Agencies and Jurisdictions

CITY OF BURBANK
OFFICE OF THE CITY COUNCIL

Jawahar P. Shah
City of Los Angeles
Public Works, Bureau of Sanitation
Wastewater Engineering Services Division
2714 Media Center Drive
Los Angeles, California 90065

**Integrated Resources Plan
Final Environmental Impact Report**

Comment Letter from Mearns Consulting Corporation
Figure 3.4-9 Update

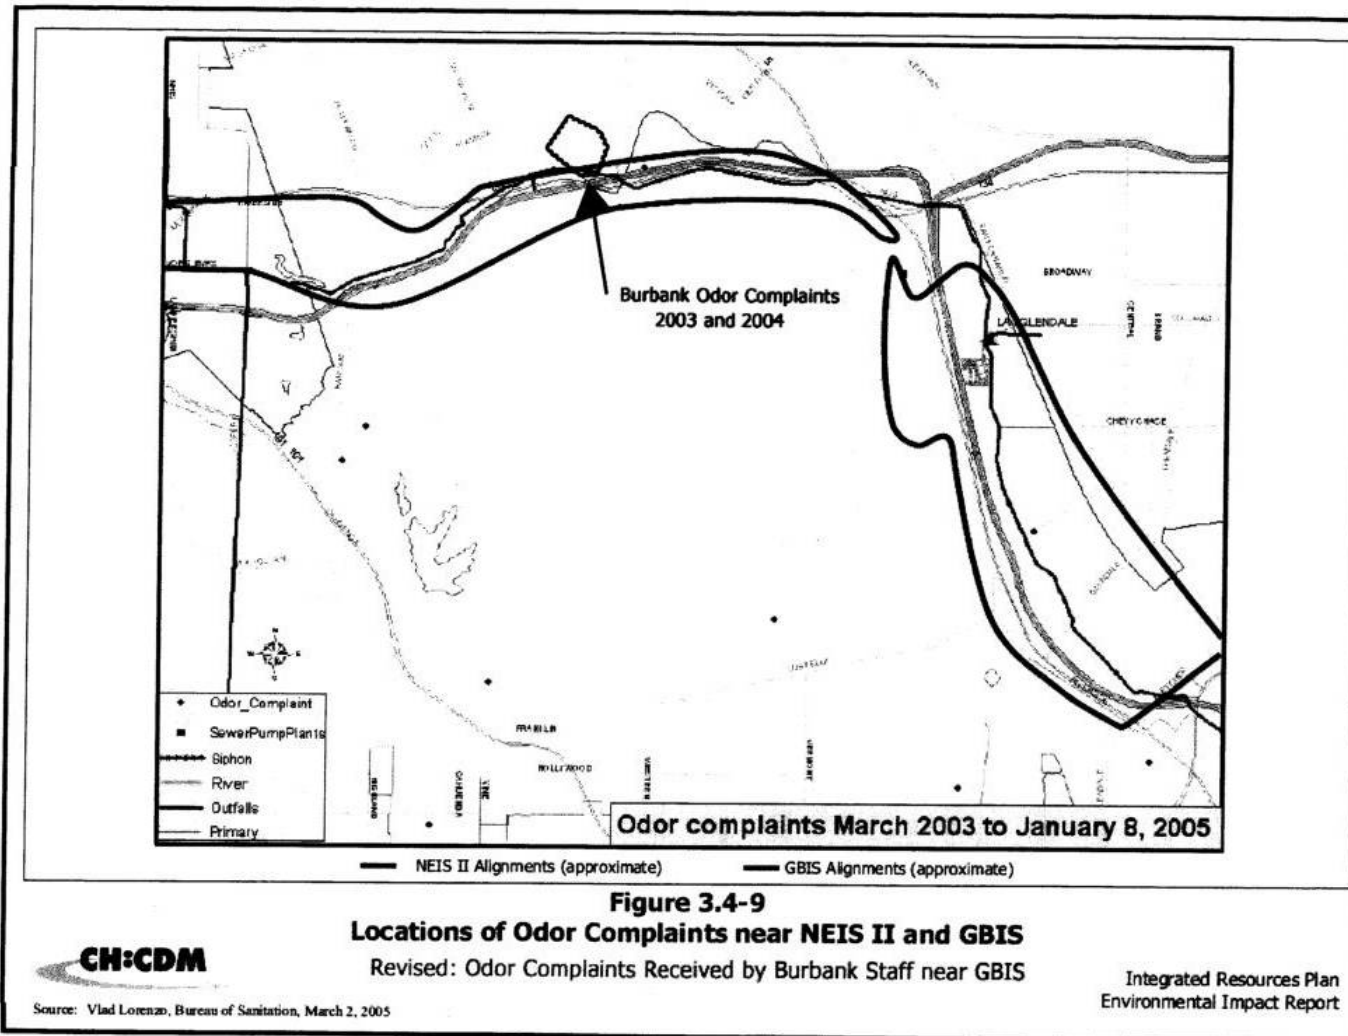
Furthermore, Figure 3.4-9, which attempts to indicate locations of odor complaints near the Northeast Interceptor Sewer – Phase II (NEIS II) and GBIS from March 2003 to January 8, 2005, is incomplete. This map may show all of the odor complaints received by the City of Los Angeles during this time, but it does not include odor complaints received by the City of Burbank. Figure 3.4-9 leads the reader to an incorrect conclusion that existing odors are not an issue in the area. In 2003 and 2004, the City of Burbank received 67 odor complaints in the vicinity of the Valley Heart site (see attached map). The North Alignment of GBIS, which includes a shaft site and ATF at the Valley Heart site, would add an additional odor source to this area.

identified (see pages 3.4-115 and 3.4-159 of the Draft EIR). In addition, mitigation measures AQ-MM-7 and AQ-MM-8 would respectively mitigate odor impacts by relocating the ATF stack to a location at least 100 feet from sensitive receptors and establish a more stringent hydrogen sulfide emission concentration at the stack. In addition, a new mitigation measure has been added, mitigation measure AES-MM-10, to provide further aesthetic mitigation. This measure would also further mitigate potential odor impacts by siting the ATF at the Valley Heart Shaft Site to the west end of the Pollywog site, which is located more than 100 feet away from residences. Under this new mitigation measure, access to the ATF would occur from Keystone Street. Section 1.5.2.2 of this Final EIR discusses the GBIS alignment that the City of Los Angeles is recommending for approval. Response to comment AJ1-1 also discusses the process and rationale for the staff recommended GBIS Alignment discussed in this Final EIR. The staff recommended GBIS Alignment would not place an ATF at the Valley Heart Shaft Site. Lastly, the odor setting in the EIR and Figure 3.4-9 have been modified to include the odor complaints reported to the City of Burbank in 2003 and 2004, as indicated in the comment letter.

As described in the response to comment AJ1-6, the odor setting related to GBIS has been revised to reflect an existing odor condition in the vicinity of the Valley Heart Shaft Site and to reflect the odor complaint information provided by the commenter. As described in the response to AJ1-6, a section of the existing NOS is located near the Valley Heart Shaft Site. Because the NOS is one of the City's oldest sewers and is subject to high flow conditions, the NOS could have contributed to some of the sewer gas odors referenced by the commenter. The installation of either of the GBIS alignments would be expected to reduce the potential for sewer gas releases from the NOS because it would relieve sewers that flow into the NOS, which would result in a reduction in flows in the NOS. High flows in sewers tend to force sewer gases out of the sewers because less air space is available above the flowing wastewater to convey the air downstream. A reduction in wastewater flows in the NOS is expected to decrease the potential for sewer gas releases from the NOS by reducing the flow in the NOS and increasing the available air space to convey the sewer gases downstream. Regarding the placement of an ATF at the Valley Heart Shaft Site under the GBIS North Alignment, the two-staged air filtration process at the ATF, described in Section 2 of the Draft EIR, would remove both hydrogen sulfide and VOCs from the sewer gases. In addition, the ATF could not operate unless it is permitted by the SCAQMD. As part of the permit conditions, the ATFs would have to demonstrate compliance with SCAQMD Rules 402 (Nuisance) and 1401 (Toxic Air Contaminants). Rule 1401 would require an estimation of human health risk impacts and a demonstration that risks would not exceed SCAQMD-mandated limits. The reduction in untreated sewer gas releases in conjunction with compliance with permit requirements from the SCAQMD is expected to keep potential impacts associated with the ATF to a minimum. In addition, a new mitigation measure has been added, mitigation measure AES-MM-10, to provide further aesthetic mitigation. This measure would also further mitigate potential odor impacts by siting the ATF at the Valley Heart Shaft Site to the west
